SUBJECT: AMENDMENT NO. 203 TO FACILITY OPERATING LICENSE NO. DPR-49 - DUANE
 ARNOLD ENERGY CENTER (TAC NO. M85339)

DUANE ARNOLD ENERGY CENTER

Amendment No. 203
License No. DPR-49

ATTACHMENT TO LICENSE AMENDMENT NO. 203

DUANE ARNOLD ENERGY CENTER IES UTILITIES INC. TECHNICAL SPECIFICATIONS
DAEC OPERATING LIMITS FIGURE 3.6-1

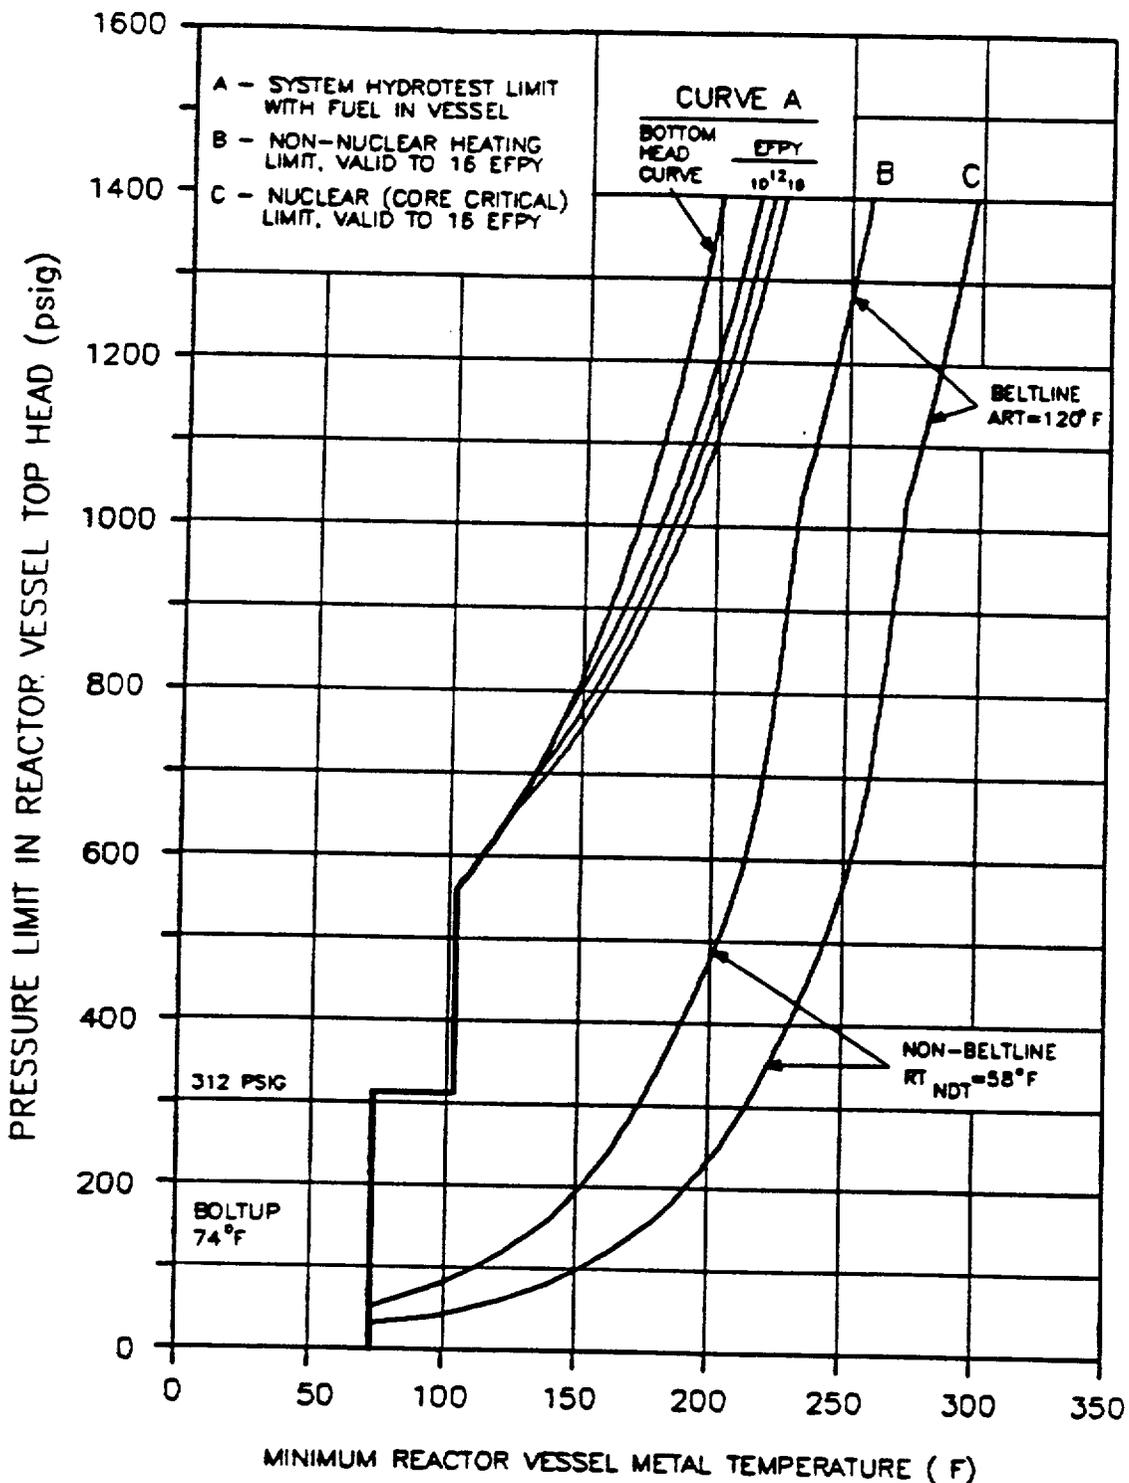
The licensee has proposed to revise TS Section 3.6.A.2 to delete from the LCO a commitment from the licensee to update TS Figure 3.6-1, Pressure versus Minimum Temperature Valid to Sixteen Full Power Years, per Appendix G of 10 CFR Part 50, prior to the expiration of 16 full power years, and to relocate the commitment to the Bases Section of the TS. This Figure gives the Pressure - Temperature Limit Curves for the DAEC reactor vessel. The staff approved Figure 3.6-1 on August 12, 1991. This commitment does not affect any surveillance requirements on the LCO, or provide any additional information to assist in the operation of the plant or in mitigating any accidents which could potentially occur. The staff has determined that this change is acceptable.

1. Average heatup/cool-down rate not to exceed 100 °F/hr
2. Reactor head required to be vented and no power operation allowed unless the reactor vessel temperature is greater or equal to Curve C in Figure 3.6-1
3. Reactor Vessel Studs shall not be placed in tension unless the temperature of the head flange and shell adjacent to the head flange are greater than 74 °F.
